Service Bulletin

MARCH

1959

NO. 345

FIG. 1

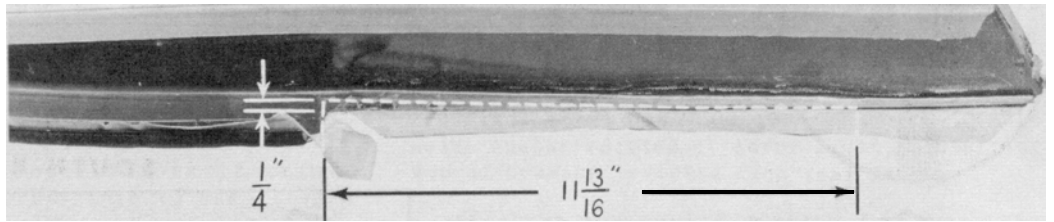
To correct the condition, it is necessary to bring the inner and outer window weather seals closer together to stabilize the quarter glass assembly when it is fully lowered. The following steps will effect a suitable improvement.

1. Remove the rear seat cushion and seat back. **Remove** the rear quarter trim retainer and peel back the vinyl trim. Measure in $1/4$ " from the offset in the retainer and mark, then toward the rear of the retainer from the $1/4$ " mark, measure $11-13/16$ " and place a mark at edge of the metal. Scribe lines to the marks, see Fig. 1.

with a hack saw, cut on the lines scribed on the metal and remove the marked section.

Place the trim back over the edges of the retainer, being careful so the trim will not be torn or damaged, and cement the trim in place. This will permit a closer fit of the assembly at the rear of the window opening in the body, when the retainer is in place.

FIG. 2

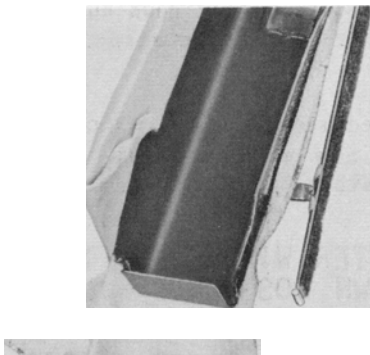
2. At the forward end of the trim retainer, bend the end metal piece slightly forward and release the first clip of the window seal, then, move the seal away from the panel sufficiently to clear the vinyl trim, permitting only one layer of vinyl to remain between the window seal and the panel, see Fig. 2.

Fig. 3

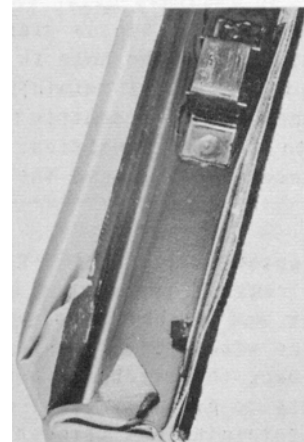
3. Fold the vinyl trim around and back of the forward end metal piece on the retainer, cementing it in place, and bend the end piece back to its original position. Note: Only one layer of vinyl now remains between the seal and retainer. Press the seal clip through the hole in the trim retainer, Fig. 3. In Fig. 4, "A" is the top view showing the original method of folding the trim on the panel and "B" the new suggested method.

FIG. 6

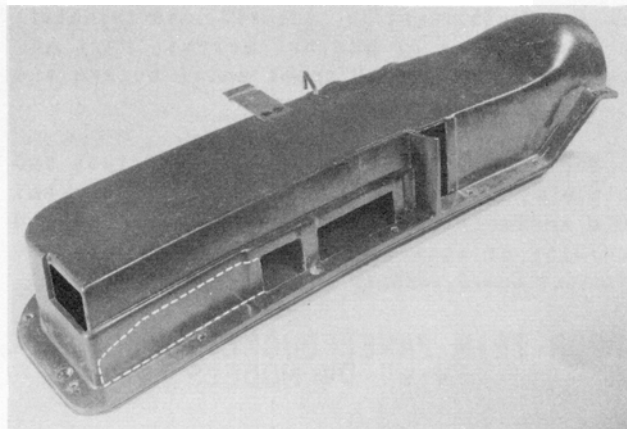
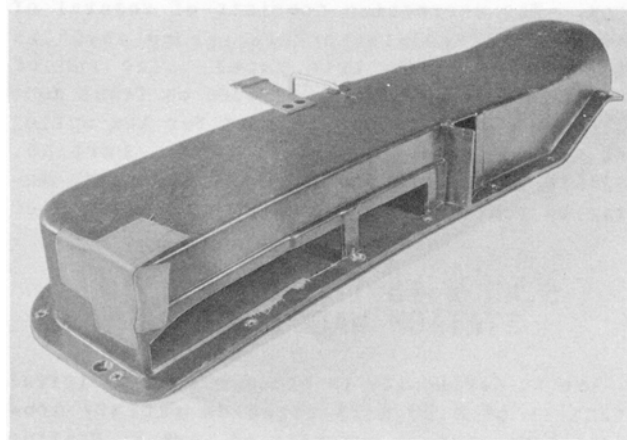
To direct more warm air to the driver's feet, a change has been made in the Climatizer air distribution duct.

3. Scribe the bottom surface of the duct, as shown by the dotted lines on Figure 6.

4. Cut the duct to revise the air outlet by extending the opening to the left (see Figure 7).

5. Use a piece of cloth adhesive tape and seal the opening at the extreme left end of the duct as shown in Figure 7.

FIG. 8

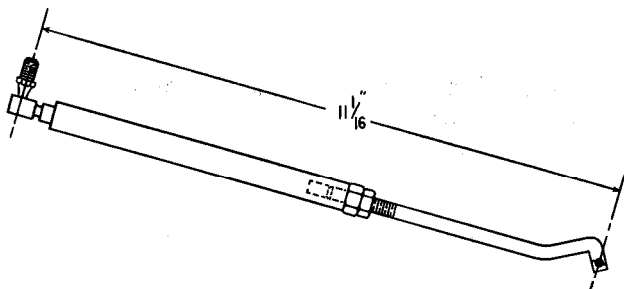
As step 1 for performing the carburetor-to-transmission throttle valve linkage adjustment, the throttle control Dellcrank-to-carburetor rod assembly (see Fig. 8) should be checked and adjusted to provide 11-1/16" between the centerline of the ball stud and centerline of the cotter pin hole. After adjusting the carburetor rod assembly to this length, it should not be altered during any subsequent adjustment operation.
